## ITASCA DOCUMENT REVIEW

File No.: 001-02-22

Document: "Evaluation of Damaged Rock Zone Around Repository Openings," Rockwell Hanford Operations Computational Brief No. 573 (March 13, 1986)

Reviewer: Itasca Consulting Group, Inc.  
(M. Board)

Fig. 1 Hoek and Brown Failure Criteria, Dense Basalt

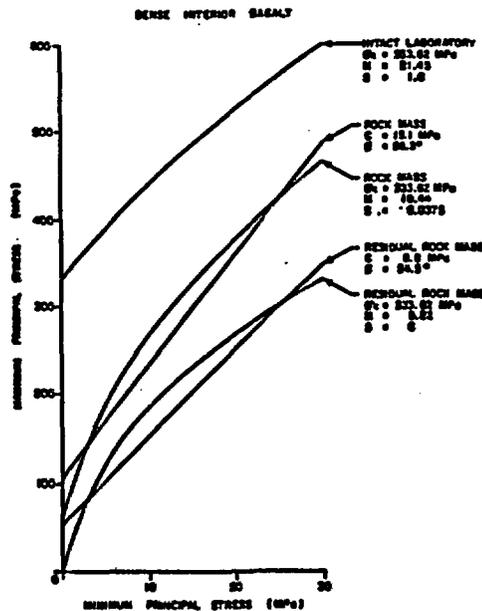
Material Properties, Initial Conditions — Two rock types were modeled in these studies: the "dense" interior basalt and the interior vesicular zone of the Cohasset Flow. Values for material constants were obtained from repository design studies by RKE/PB (McElrath, 1984; RKE/PB, 1985). These studies obtained empirical failure constants  $m$  and  $s$  for the Hoek and Brown (1980) yield criteria from the Rock Mechanics Data Package compiled by Sublette (1983). The design models used in the present analysis require the explicit plasticity parameters  $c$  (cohesion) and  $\phi$  (friction). Mitchell (1984) has used an empirical procedure given by Hoek and Brown (1980, p. 515) to determine these properties from the  $m$  and  $s$  curve fit parameters. The strength envelope for dense basalt is given in Fig. 1 and the corresponding properties in Table 1. The envelope and properties for vesicular basalt are given in Fig. 2 and Table 2, respectively.

As seen in the tables, the values derived for the rock mass friction angle is very high at  $58.3^\circ$  for the dense basalt and  $49.5^\circ$  for the vesicular zone. These values are far higher than generally used in practice for similar hard rocks and is higher than the  $35-45^\circ$  range for joints given by Sublette (1986). The cohesive strength assigned to the rock mass is also quite high at 15.1 MPa. The presence of infilling materials will possibly result in this high value. It is stressed here that these values are not conservative.

Fig. 3 Nomenclature for the Bray Elasto-Plastic Solution

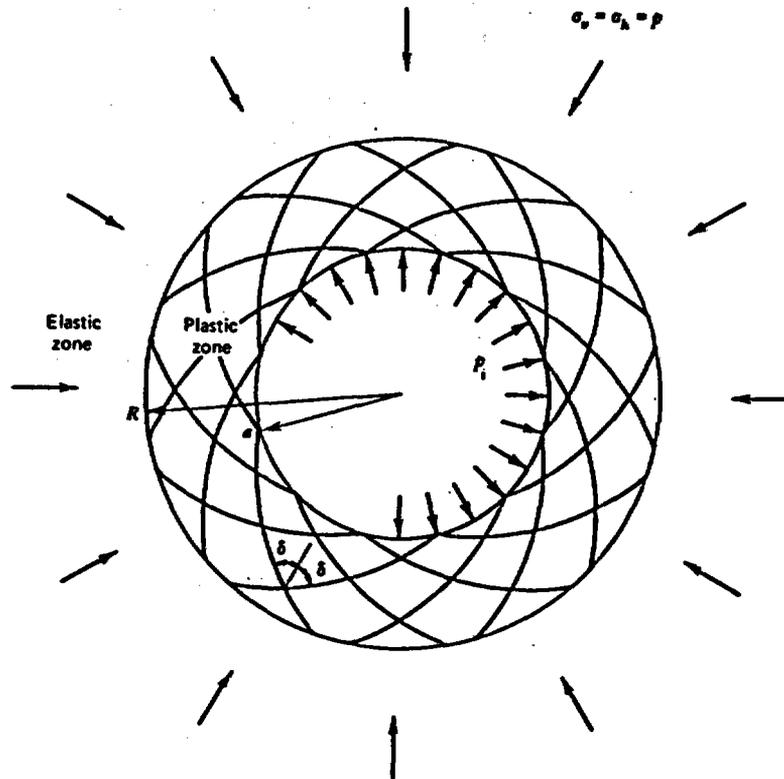
A simple check on these calculations is performed by using the elastic-plastic formula for a hole in an infinite plate under hydrostatic stress developed by Bray (1967, Fig. 3). The radius of the yield zone is given by

Calculations using this formula are summarized in Table 6. For the same input properties, Bray's solution (1967) checks well with Mitchell's results. We wish to vary the rock mass properties to illustrate the lack of conservatism in the analyses. As seen in this table, the effect of varying the internal friction angle of the material is quite significant. Normally, when the rock mass is considered to be a continuum, a conservative analysis will assign mass plasticity properties to be those of the joints. If the friction angle of the mass is reduced from 58.3° to 35° (a typical value assumed in scoping studies), the thickness of the yield zone will increase by a factor of 8 using the standard plasticity formulae. If conservative stresses are selected, the thickness of the yield zone can become significant.

Fig. 5 Yield Zone Determined By FLAC For Case of 5 MPa Cohesion

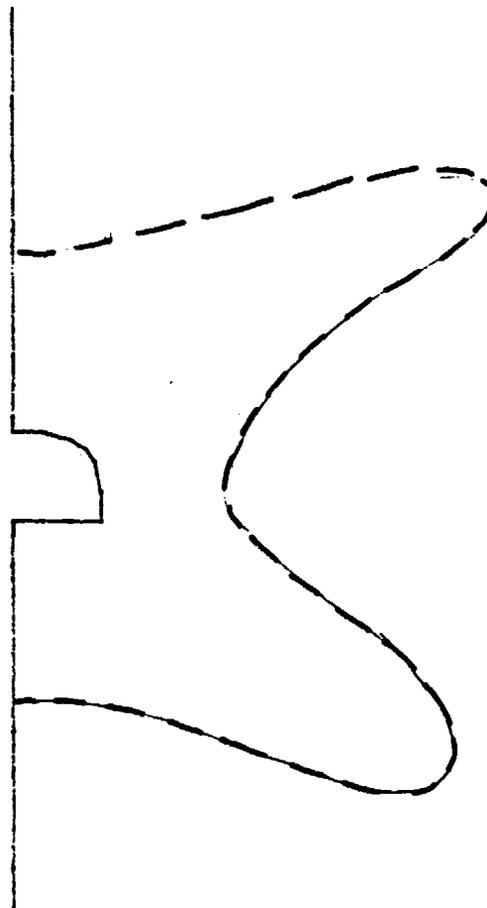
A Mohr-Coulomb plasticity constitutive law (as in VISCOT) was used for the rock mass. The resulting yield zone for the case of 15 and 5 MPa cohesion is illustrated in Fig. 4 and 5. For the 15 MPa cohesion, a maximum yield zone radius of slightly less than 1 radius is indicated. A reduction of cohesion to 5MPa (not unusual for joints) indicates a yield zone of roughly 1-2 diameters of the opening. Associated plots of shear stress contours and principal stress vectors for the case of a 5 MPa cohesion are given in Figs. 6 and 7.

These calculations were given to illustrate the large effect of choice of plasticity parameters on the apparent disturbed zone about the openings. It seems clear that plasticity parameters obtained from intact rock will result in highly non-conservative answers. Values obtained from non-healed joints will likely yield conservative results. A true determination of the radius of the disturbed zone will not be known until the ES test measurement of full-scale response.
